Comments on #SDP-26-0005 - Planning & Zoning: Site Development Plan

Application Number: #SDP-26-0005
Application Type: Site Development Plan
Date: August 28, 2026
Address: 4502 VINEYARD PINE LN, ROLESVILLE, NC 27571
Parcel: 1758453022

Vineyard Pine Commercial (SDP-26-0005)
MRR Development, LLC
Rolesville, Wake County, North Carolina

Vineyard Pine Commercial Rev 3 SDP-26-005 072826.pdf · Page 8 · August 20, 2026, 10:04am

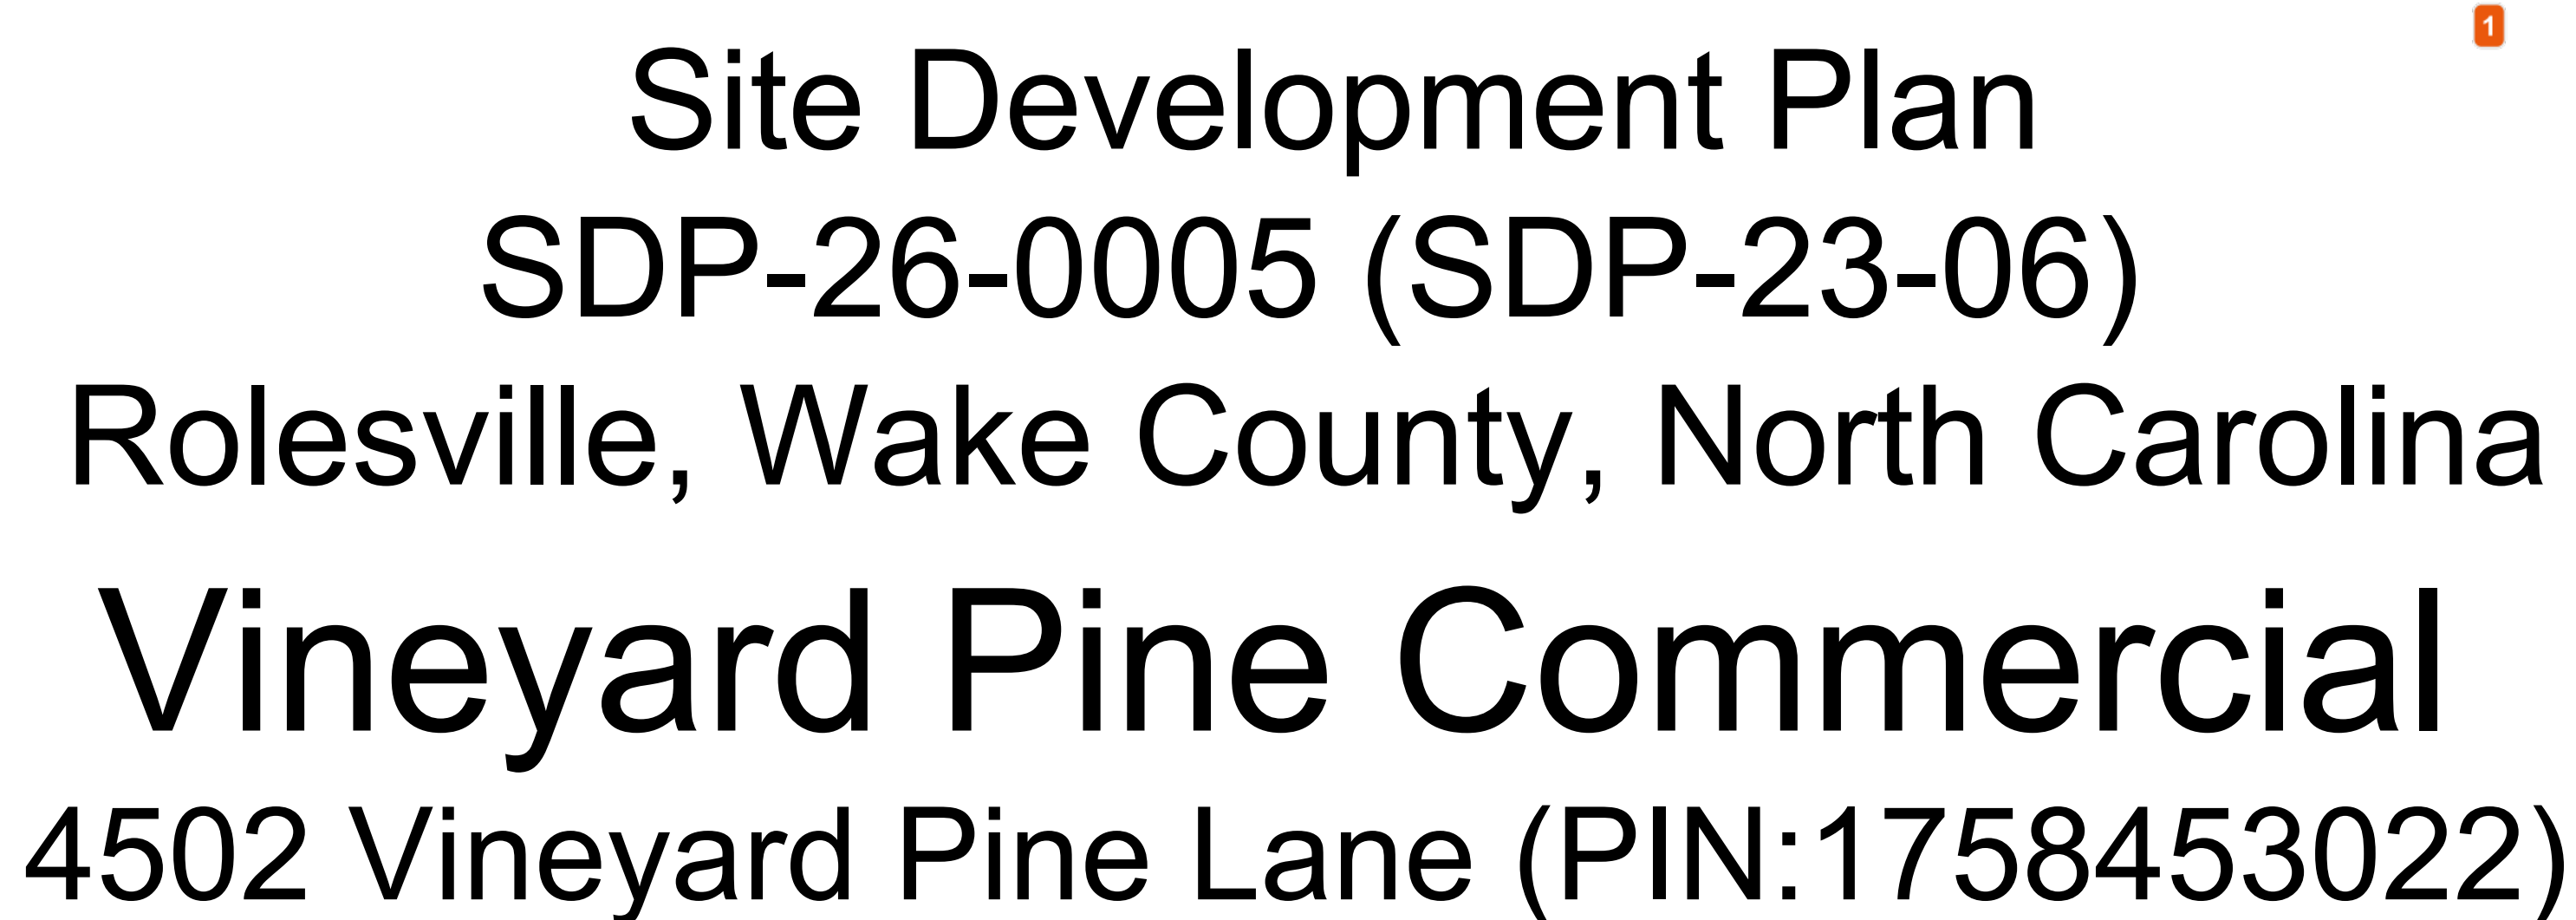
Pls bubble or note confirmation of MG's previous request to remove the fence per TA-26-0005, which included amendments to perimeter buffers. Plant materials only may be used.

Please include fencing details to match Town standards per LDO Section 6.5 - Fences, Walls, and Berms

Cover Sheet

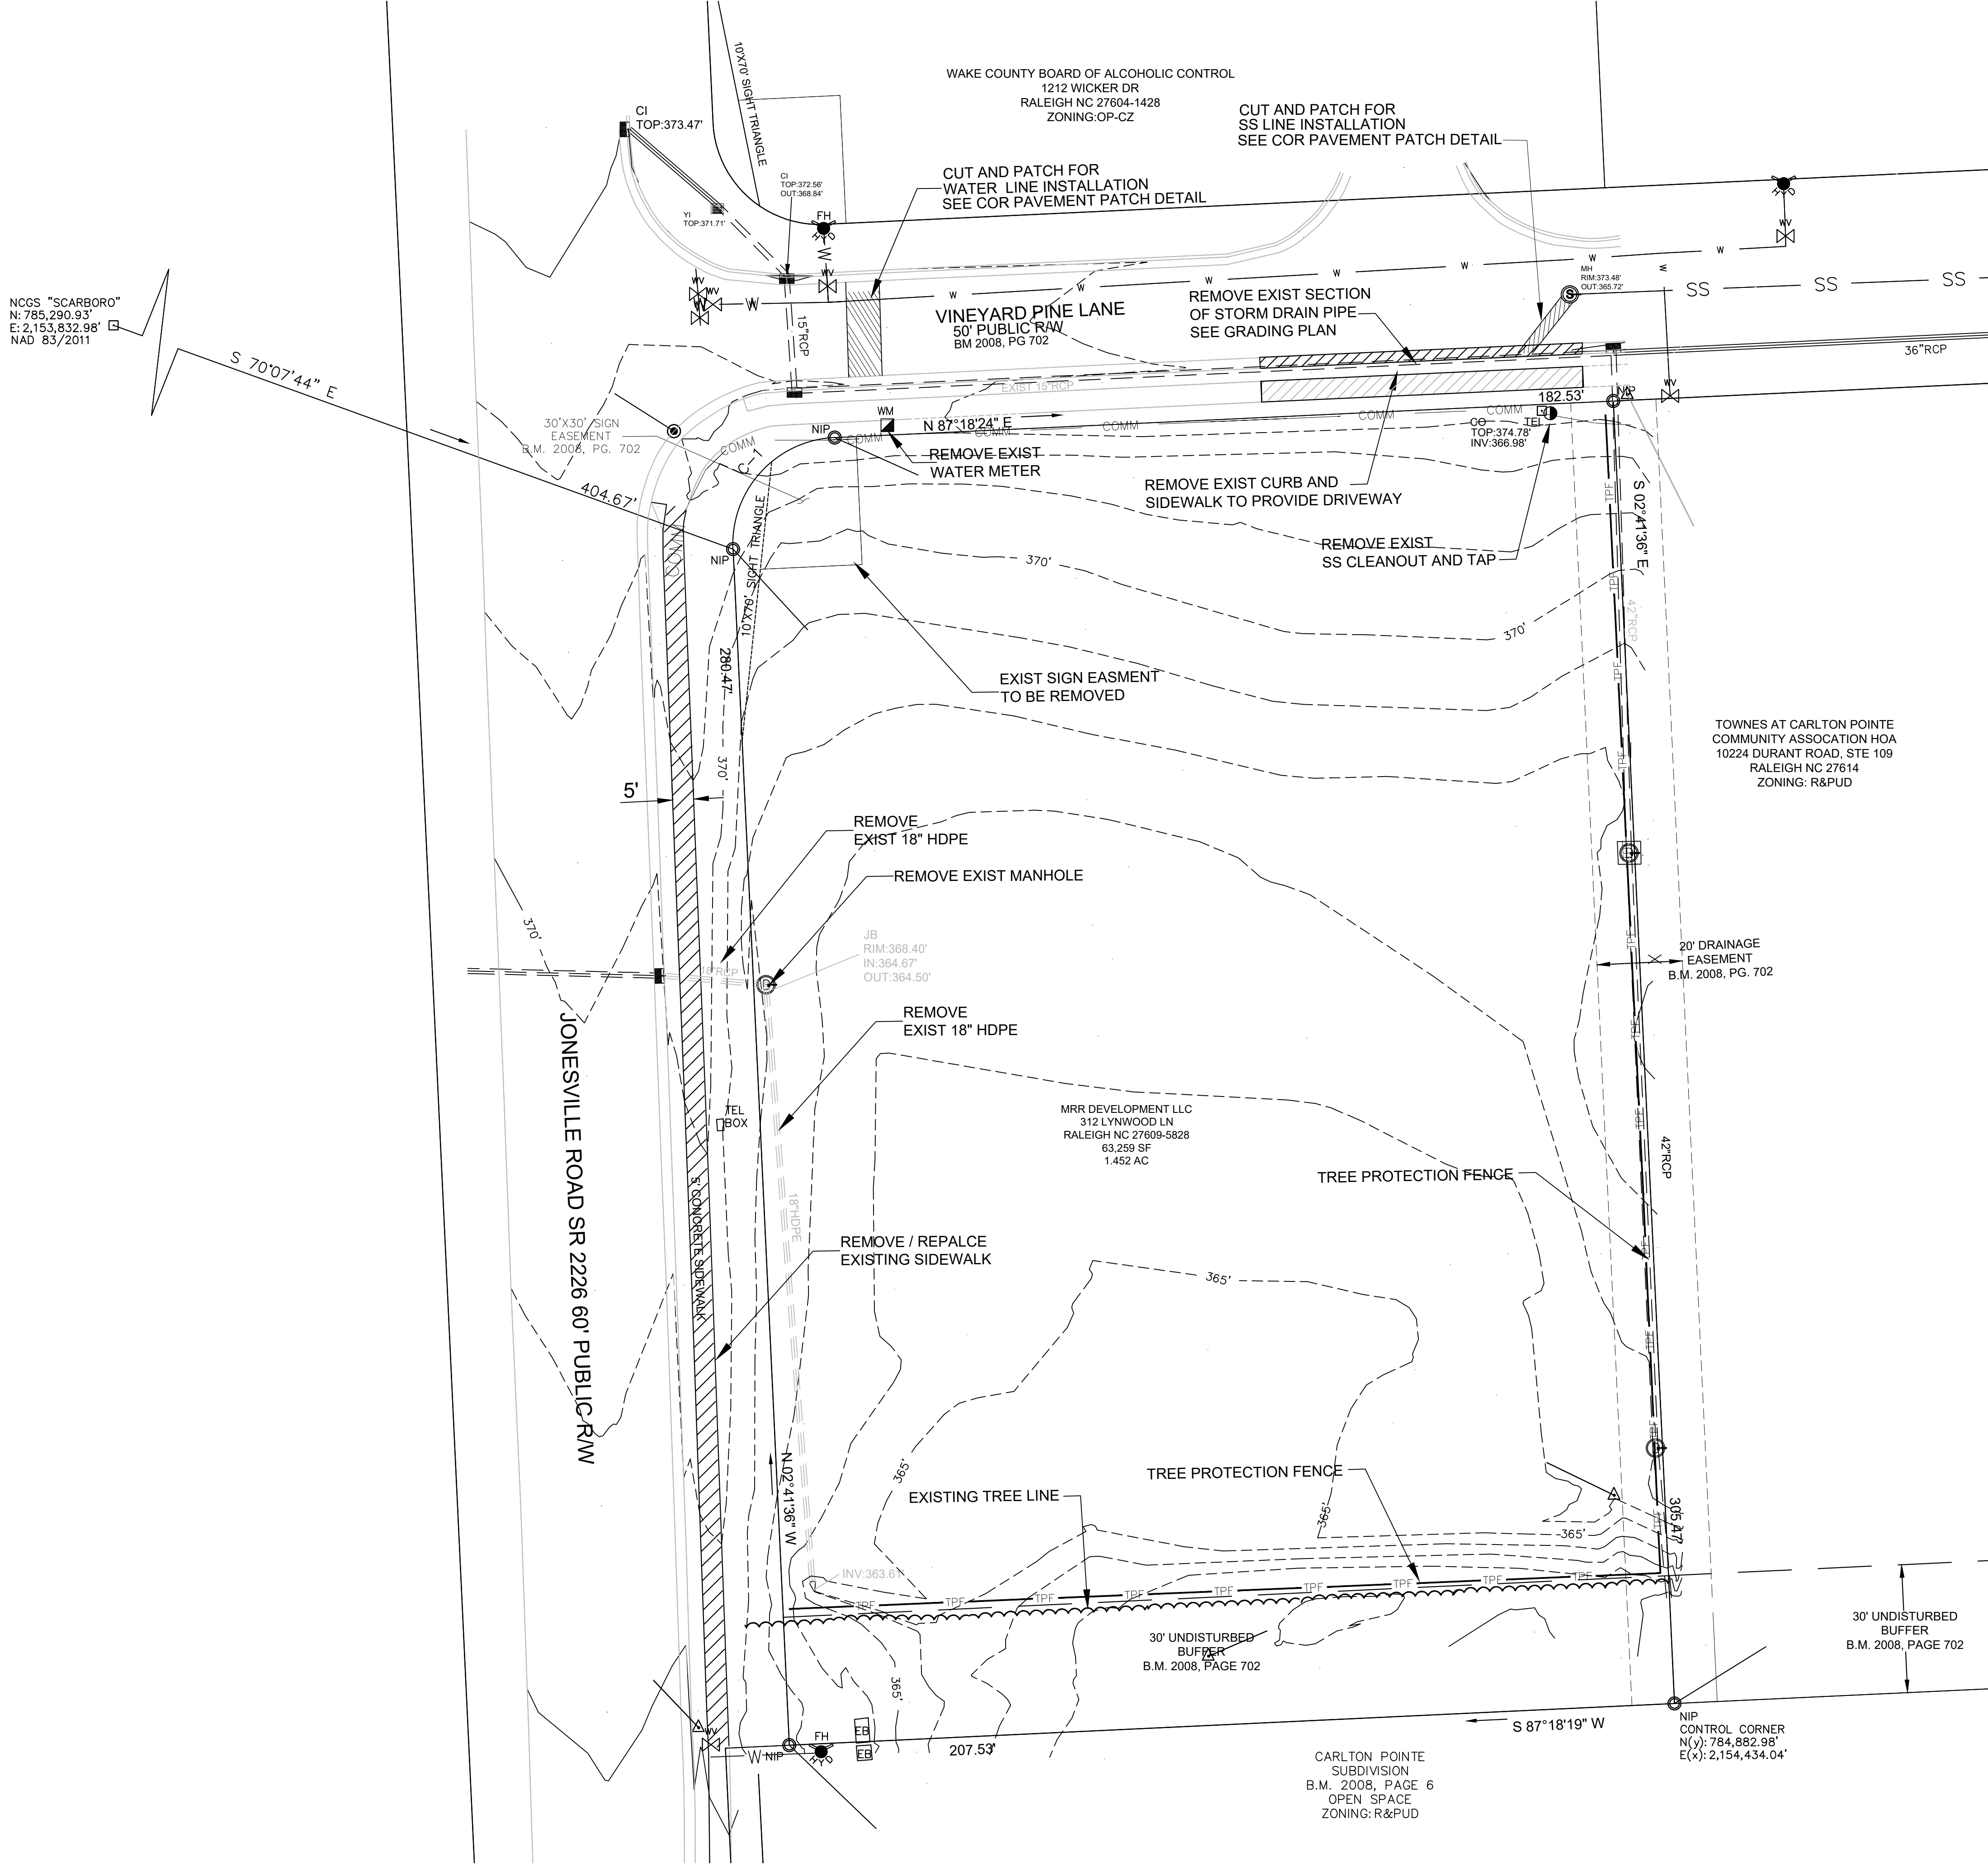
The Legal Description field was filled out with 'Commercial Retail Development', which describes the proposed use rather than the legal description of the property. Please update this field to provide the actual legal description (e.g., Book of Maps/Page or Register of Deeds Book/Page), such as 'BM 2008, PG 702'.

The proposed impervious surface area listed on the Cover Sheet (Sheet C0) is 47,652 SF (1.09 acres). However, the uploaded Wake County Watershed Management Approval (SEC-175078-2026) permits a maximum impervious surface of only 45,302 SF (1.04 acres). Please revise the plans to ensure the proposed impervious surface does not exceed the permitted amount, or provide an updated Wake County approval that matches the proposed design.

Utility Plan
Vineyard Pine Commercial (SDP-26-0005)
MRR Development, LLC
Rolesville, Wake County, North Carolina

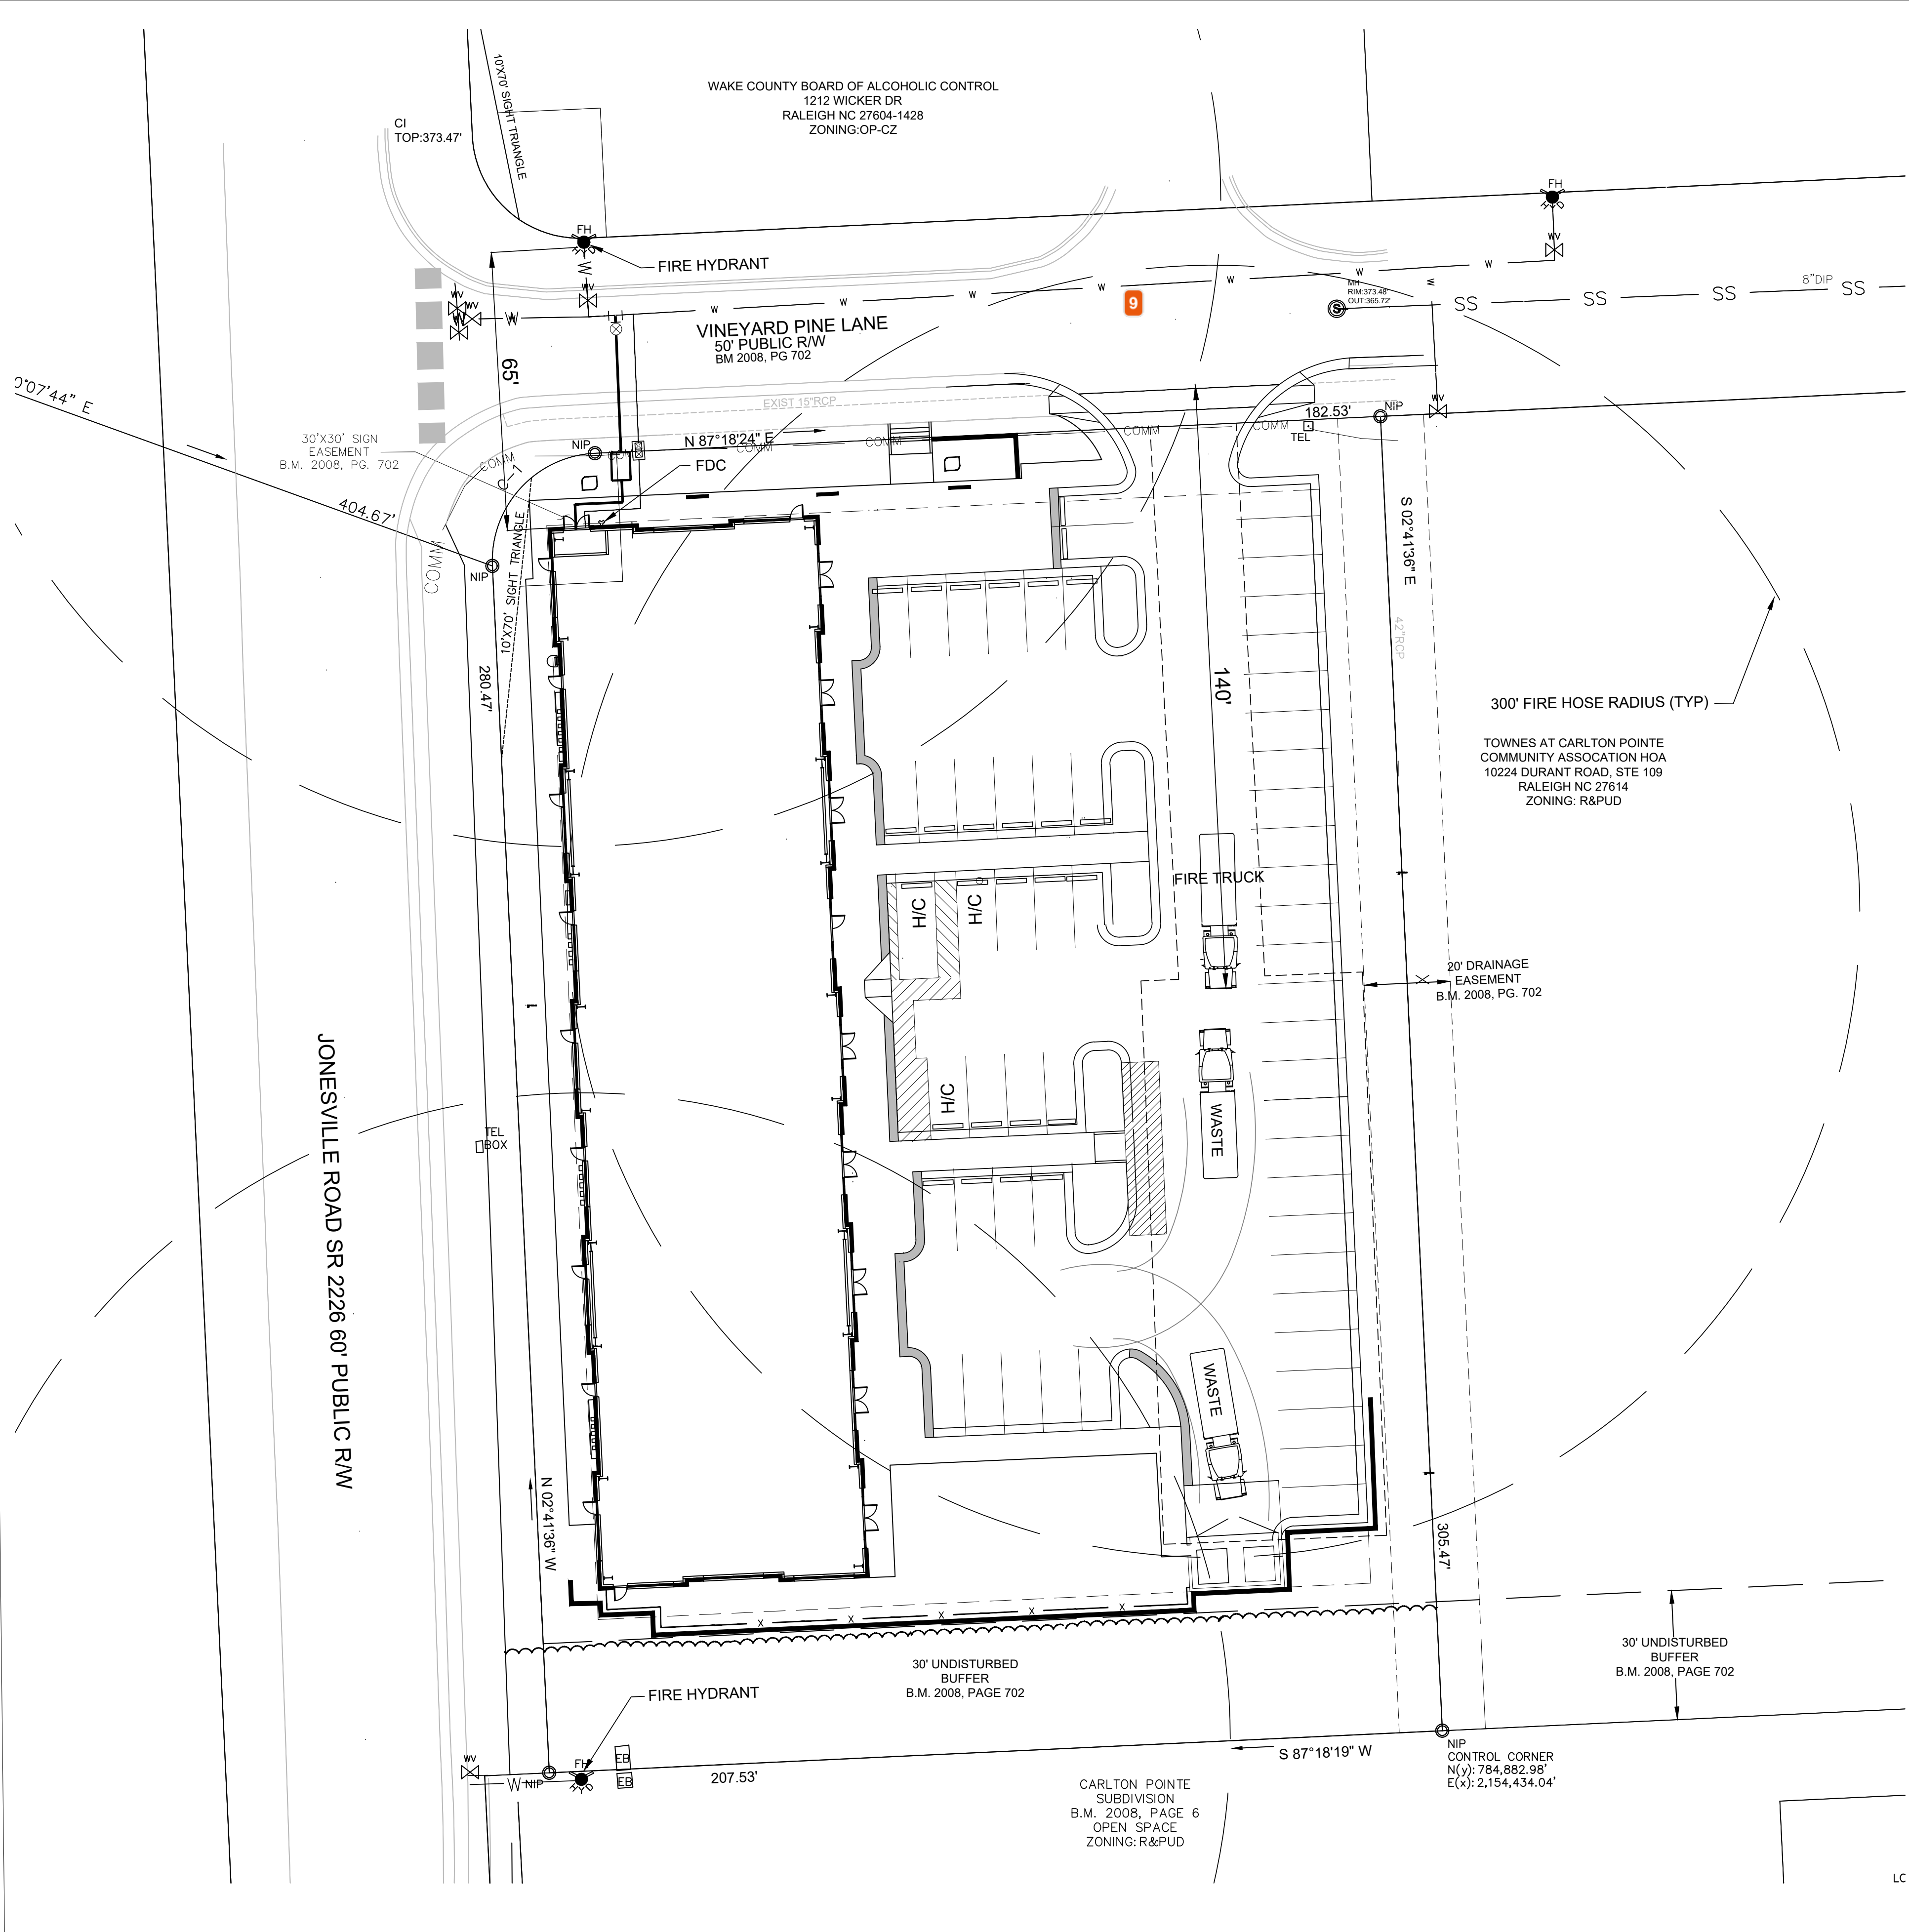
This utility sheet is not complete. Missing water and sewer labels. See Energov for complete COR comments.
